Fourth Preliminary Consultation
MONTGOMERY COUNTY HISTORIC PRESERVATION COMMISSION
STAFF REPORT

Address:	9832 Capitol View Ave., Silver Spring	Meeting Date:	3/11/2026
Resource:	Spatial (undeveloped) Capitol View Park Historic District	Report Date:	3/4/2026
Applicant:	Mark Kaufman (Michael Winfield, Agent)	Public Notice:	2/25/26
Review:	4 th Preliminary Consultation	Staff:	Dan Bruechert
Proposal:	Construction of single-family dwelling, tree clearing, hardscape, and associated sitework

Figure 4: Streetscape study showing the subject property and several adjacent properties along Capitol View Ave. (a larger version of the study is included in the application materials).

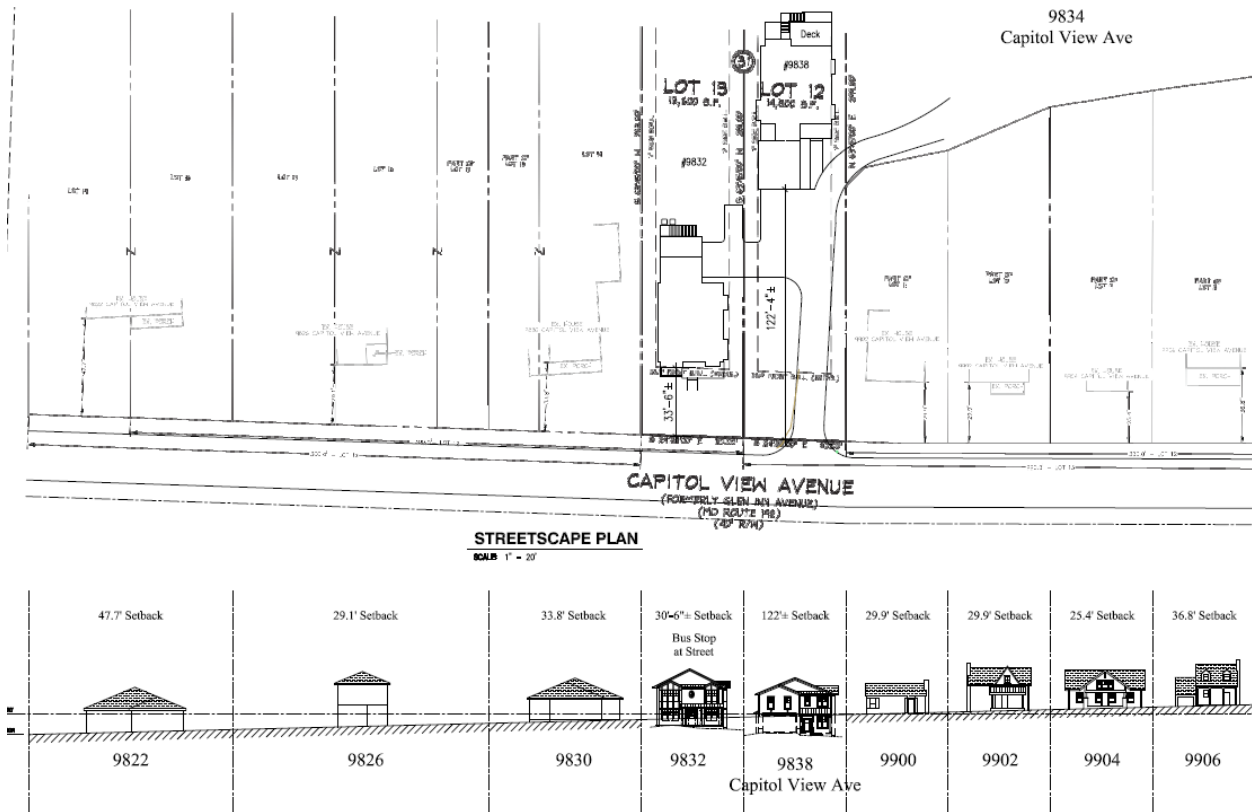
Staff finds the proposed house still threatens to overwhelm the house at 9830 Capitol View Ave. and that it remains fundamentally incompatible with the prevailing building patterns, massing, and size of houses within the district and on this portion of Capitol View Avenue in particular. Staff recommends the house be lowered so that it presents as two full stories and no more on the façade. Staff also finds that breaking up the house massing, particularly at the front, would help the house appear smaller and more compatible with the character of the district. As stated above, this could be accomplished by creating a roof form with two gables, like the infill construction at 9905 Capitol View Ave. or a gable-L form at the approved house at 10201 Menlo Avenue (see Figs. 5 and 6, below).

ARCHITECTURAL SITE PLAN

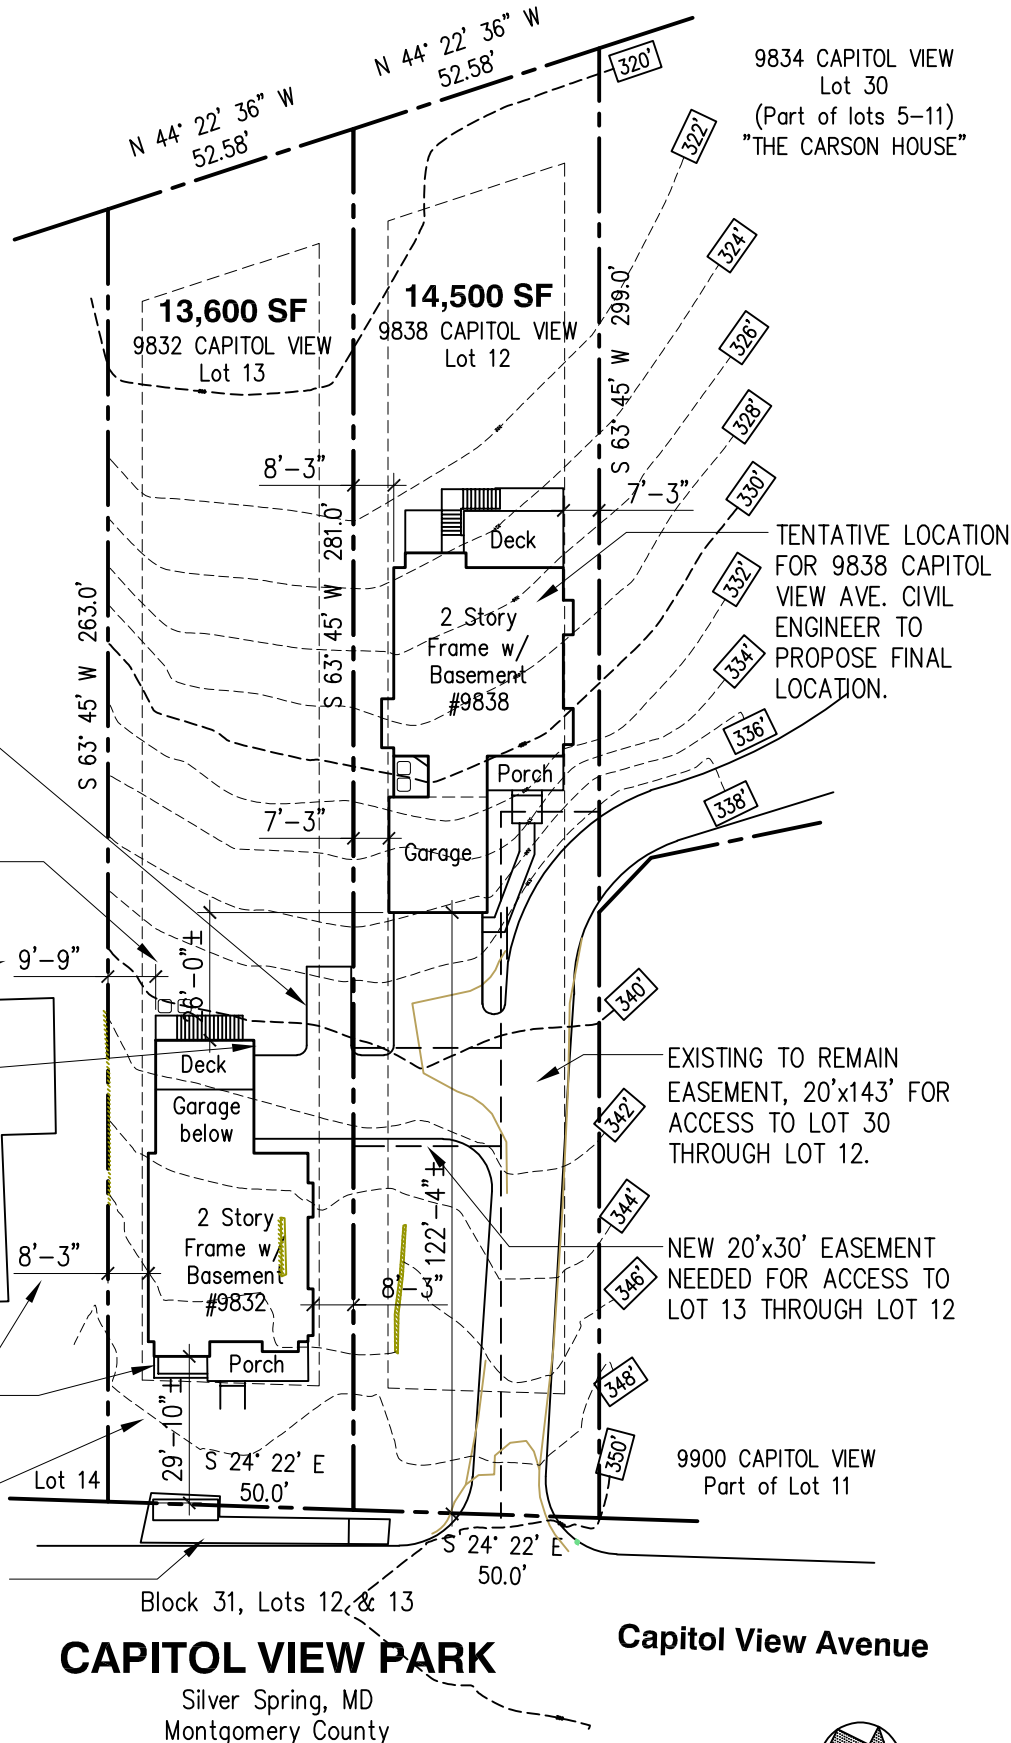
Based on feedback at the 1st Preliminary Consultation, the applicant developed a house plan with the attached, side loading garage at the rear. This allows the house to be placed much closer to the street, however, a portion of the proposed house will be obscured by the existing bus shelter. The front wall plane of the proposed house will be 29' 10" (twenty-nine feet, ten inches) from the property line adjacent to Capitol View Ave. When comparing the adjacent streetscape Staff notes that many of the houses to the north of the subject property along Capitol View Ave. were built closer to the street than current zoning allows. At the November 2023 (second) Preliminary Consultation, the HPC concurred with Staff's finding that the revised front setback is generally consistent with its neighbors and reinforces the existing pattern of construction along the streetscape.

The side setbacks of the house have been increased on each side from 7' 9" (seven feet, nine inches) to 8' 3" (eight feet, three inches). While any increase in the side setbacks is positive, Staff finds a 6" (six inch) increase to not be truly substantive change.

FRONT ELEVATION

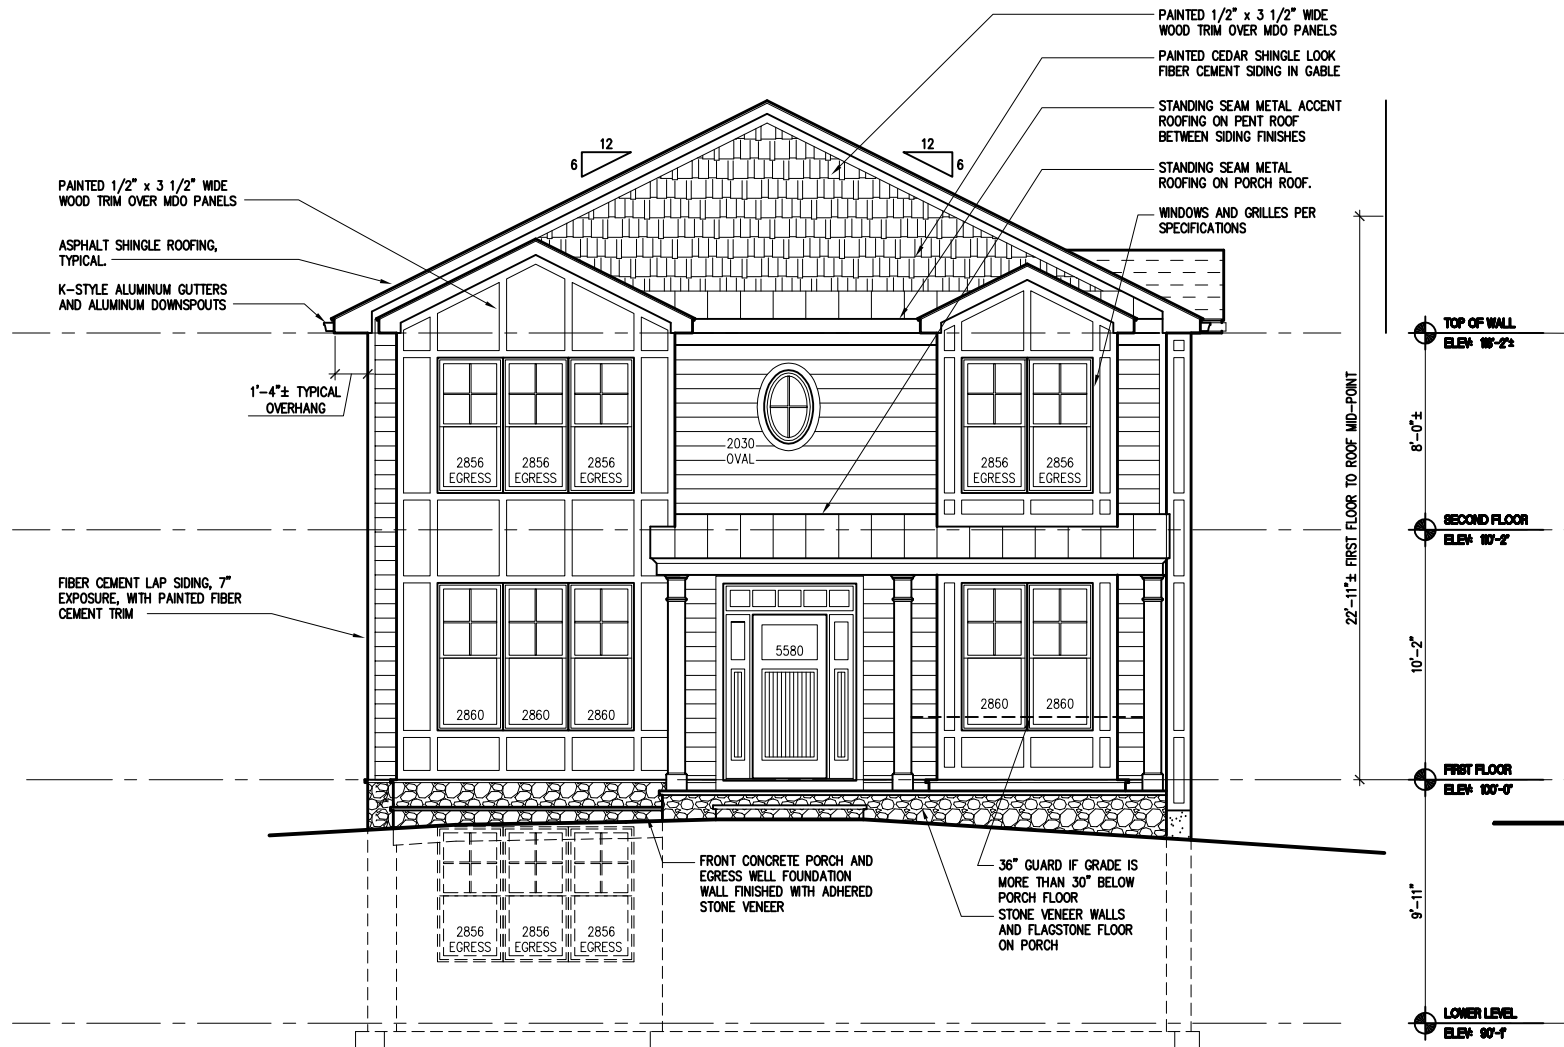
The proposed house is two stories tall with an attached side-loading two-car garage at the basement level in the rear. The house design submitted is virtually identical to the design presented at the previous Preliminary Consultation. The main house mass measures 38' 4" × 32' 6" (thirty-eight feet, four inches deep by thirty-two feet, six inches wide), with an additional 13' × 20' (thirteen foot deep by twenty foot wide) section above the attached garage in the rear. The footprint of the proposed house did not change from the previous Preliminary Consultation. The house measures 22' 11" (twenty-two feet, eleven inches) from the first floor to the roof mid-point. This is 9" (nine inches) shorter than the design presented at the second Preliminary Consultation but is identical to the design at the third Prelim. While Staff acknowledges, for zoning purposes, the mean roof height measurement is the required calculation, in order to assess visual impact and compatibility and to evaluate proposed construction in a historic district, the ridge height is the more appropriate measurement and allows the HPC to better compare the proposal to the surrounding streetscape. Sheet dd8 appears to show the ridge is 27' 7" (twenty-seven feet, seven inches) above the first floor; however, the notation on the sheet is difficult to read and Staff requests confirmation of this measurement.

There are two revisions to the massing of the house. The first revision to the design is the reduction of the size of the right side projecting bay by 1' (one foot). Removing 1' (one foot) from this feature allowed the increase of the side setbacks discussed above. The second revision is the inset from the left bay on the front elevation was moved 4" (four inches) from 10" to 1' 2" (ten inches to one foot, two inches).

Staff finds the proposed house has not been substantially revised and more needs to be done to reduce the perceived size and mass of the house. A final recommendation that has been successful in some applications is to design the house so that the form looks like a house with a large addition. This creates the appearance of two smaller masses which helps reduce the overall visual impact.
